This document contains FAQs that were approved since the last revision of NEI 99-02. The following table has the most recently approved FAQs toward the top of the list.

FAQs - By Cornerstone/PI

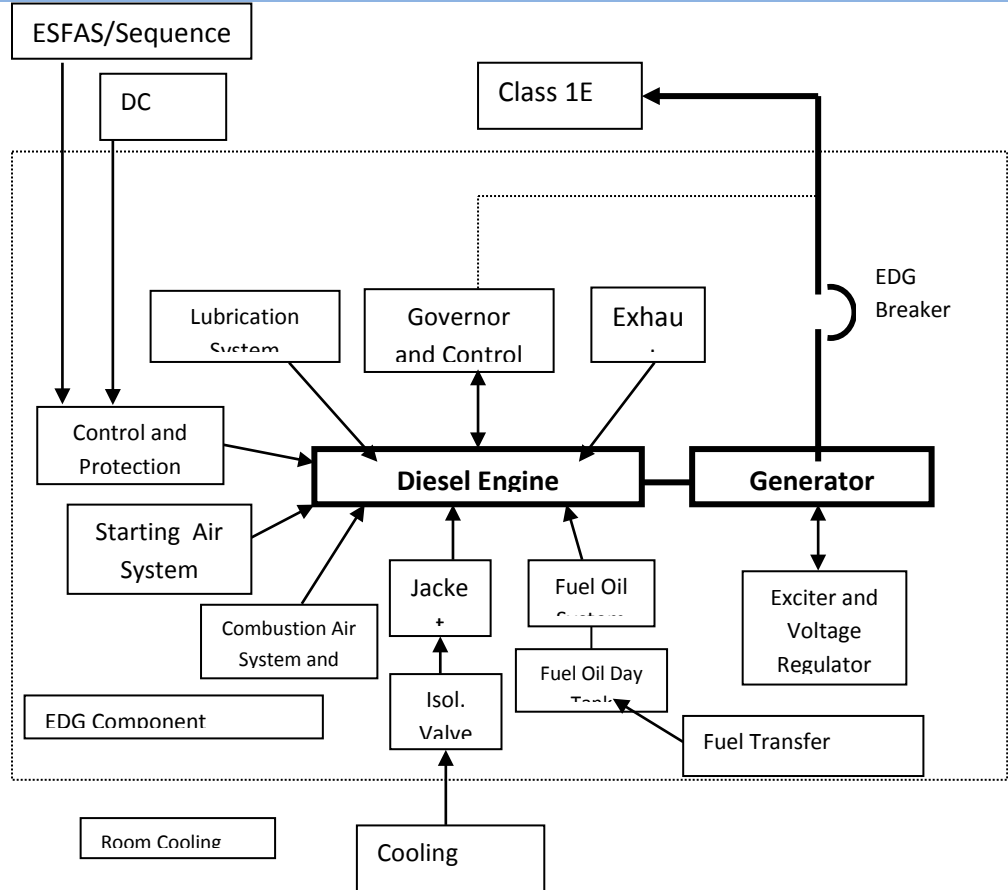
The EDG component boundary includes the generator body, generator actuator, lubrication system (local), fuel system (local or day tank **and fuel oil transfer pumps/valves**), cooling components (local), startup air system receiver, exhaust and combustion air system, dedicated diesel battery (which is not part of the normal DC distribution system), individual diesel generator control system, cooling water isolation valves, circuit breaker for supply to safeguard buses and their associated control circuit. Air compressors are not part of the EDG component boundary.

The fuel transfer pumps required to meet the PRA mission time are within the **EDG component** system boundary but are not considered to be a **separate** monitored component for reliability monitoring in the EDG system. Additionally they are monitored for contribution to train unavailability only if **the fuel oil transfer pump(s) is (are) required to meet the EDG mission time (as specified in Section F.2.2.2 and as defined in the MSPI Definition of Terms section)**. ~~an EDG train can only be supplied from a single transfer pump. Where the capability exists to supply an EDG from redundant transfer pumps, the contribution to the EDG MSPI from these components is expected to be small compared to the contribution from the EDG itself. Monitoring the transfer pumps for reliability is not practical because accurate estimations of demands and run hours are not feasible (due to the auto start and stop feature of the pump) considering the expected small contribution to the index.~~

(See also EDG failure to run definition in Section F.2.2.2. (FAQ 11-08))

Figure F-6

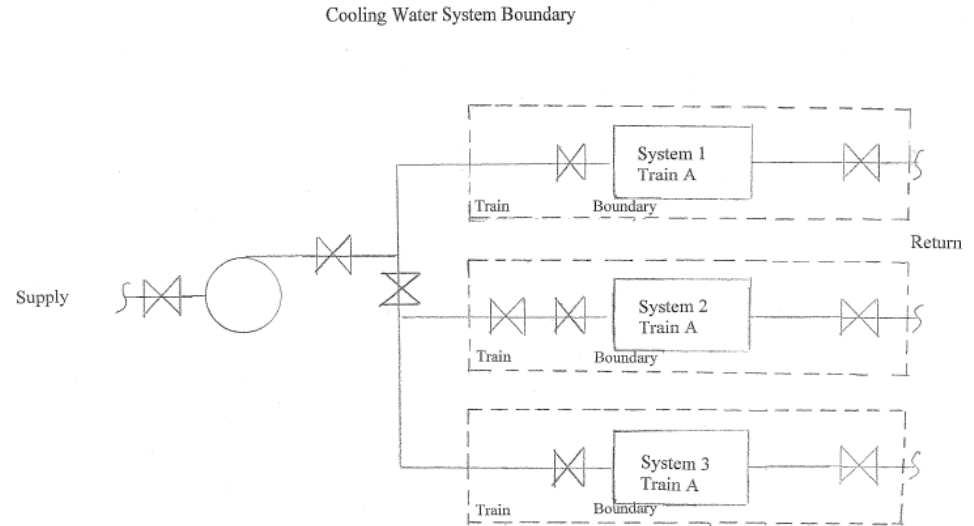
Pumps, valves, heat exchangers and line segments that are necessary to provide cooling to monitored trains or segments of system(s) supported by the cooling water system are included within the cooling water system boundary up to, but not including, the isolation valve(s) that connects the cooling water system to components in a single monitored train or segment of the supported system. This isolation valve is included within the boundary of the monitored train or segment of the supported system. The last valve(s) that provides cooling to SSCs in more than one monitored train or segment of supported system(s) is included within the boundary of the cooling water system. All valves (e.g., manual isolation valves or motor operated valves) in a cooling water line to a single monitored train or segment of a supported system are included within the boundary of the monitored train or segment of the supported system. Figure F-6 depicts this concept and the treatment of multiple isolation valves. The SSCs outside the dashed boxes are included within the boundary of the cooling water system. The SSCs within the dashed boxes are included within the boundaries of the supported systems.

Diagram 1: Low flow area with debris build-up behind Boot

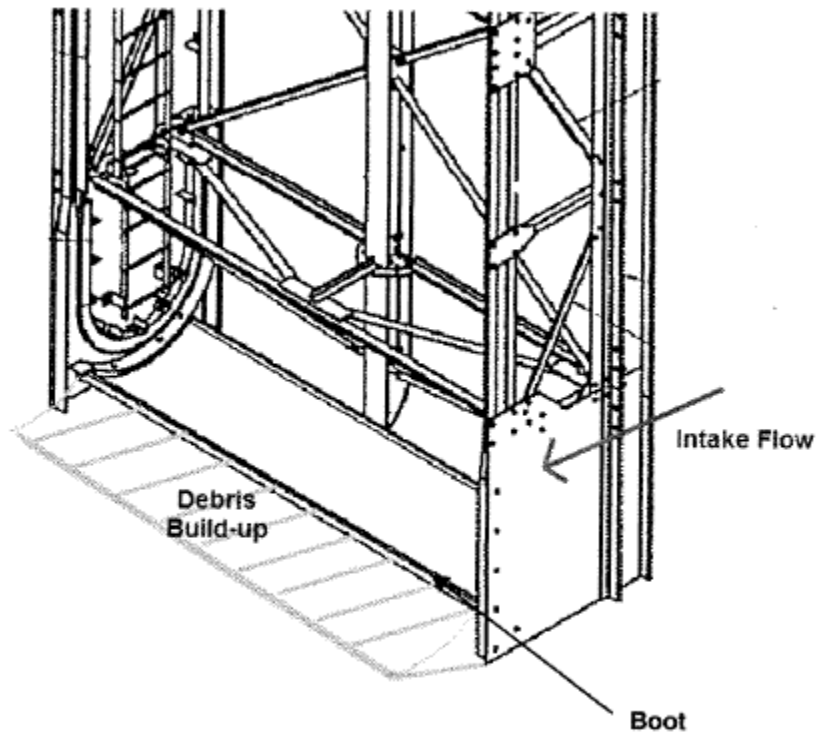
boot. There is a possibility for small debris such as silt, sand, and broken zebra mussel shells to settle in this area south of the screens (pump suction side). In this area, the silt may settle out past the boots and build up to a level to meet up with the process flow. This condition would only take a short period of time to build-up and then would remain in the condition until cleaning could remove the debris.

During normal operation, this debris build-up is not a significant threat to fouling because the debris is settled. However, this area becomes vulnerable when the gates are installed because of the change in flow patterns and increased velocity.

These downpower events should be excluded from the indicator. The licensee had experienced condenser fouling with the original traveling water screen design and although the travelling water screens had been replaced with a new design that previous operating experience was considered in planning the work on the new screens. The licensee took reasonable steps to prevent intrusion by cleaning the forebays and provided normal operating procedural guidance for monitoring condenser differential temperatures and backwashing the condenser water boxes. Since this was the first time the boot inspections had been performed, there was no way to reasonably anticipate that the debris south of the travelling water screens would have been sufficient to cause the observed condenser fouling. In addition, the on-line schedule for that week had a contingency action to perform a downpower in order to support backwashing activities. This was shown as a contingency because there is no way to accurately predict if the condenser will foul or the speed with which it will reach a point requiring a downpower.

Figure 1, Load and current profile during DG3 Operation on 2/28/10

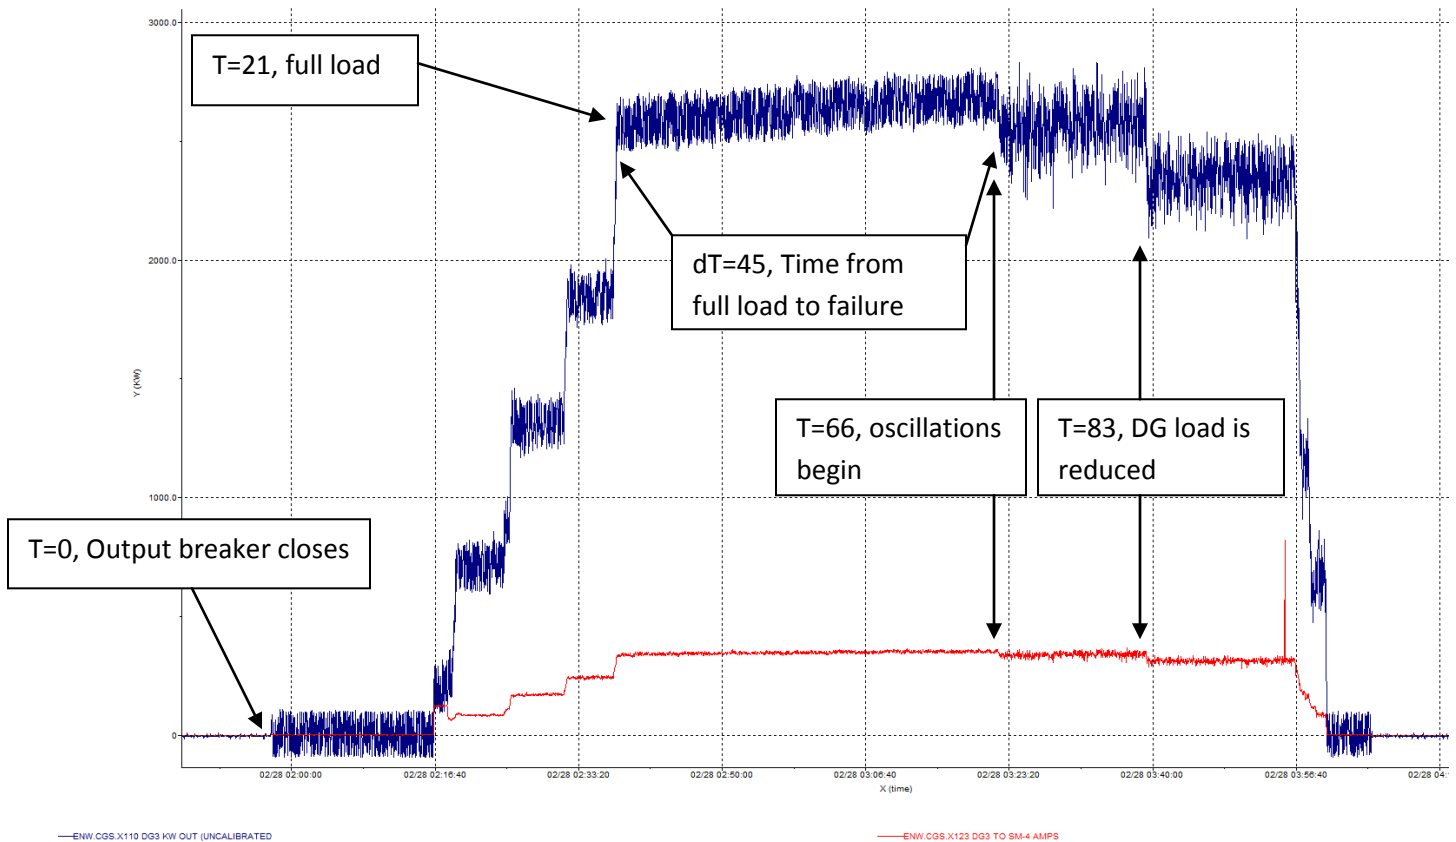
On February 28, 2010, CGS was testing an Emergency Diesel Generator (EDG). Refer to figure 1 for Load and Current trace of the subject event. The EDG successfully started, the EDG output breaker successfully closed (T = 0 minutes), the EDG successfully load sequenced up to fully loaded (T = 21 minutes), after 45 minutes the EDG experienced unexpected load oscillations of 350 kw (T = 66 minutes), after 17 minutes the load was lowered (T = 83 minutes) and the 350 kw oscillations were observed to continue another 16 minutes of operation until the EDG was unloaded (T = 99 minutes) and shut down.

The NRC staff evaluated this issue based on the characteristics of the EDG failure (i.e., the functional response of the EDG and the failure mechanism), and applying reasonable decision-making using the guidance in effect at the time of the failure. The oscillations were caused by foreign material in the governor – a condition that had existed for several years and that did not impact prior breaker closure and sequencing operations. Figure 1 in this FAQ shows that the oscillations did not occur during the breaker closure or the load sequencing or gradual loading action. Rather, the oscillations occurred 66 minutes after breaker closure and 45 minutes after the full load (for purposes of the test run) was achieved, which is indicative of a challenge to the EDG’s ability to continue to run for its mission time. Even though the foreign material existed in the governor for several years, the EDG had started and load sequenced several times without failure. Therefore, this failure appears to have been exacerbated by the running (vice start or loading) of the EDG.

Because Figure 1 data is more reflective of an EDG failure-to-run for its mission time rather than a loading failure, the EDG failure at Columbia should have been reported as a failure-to-run.
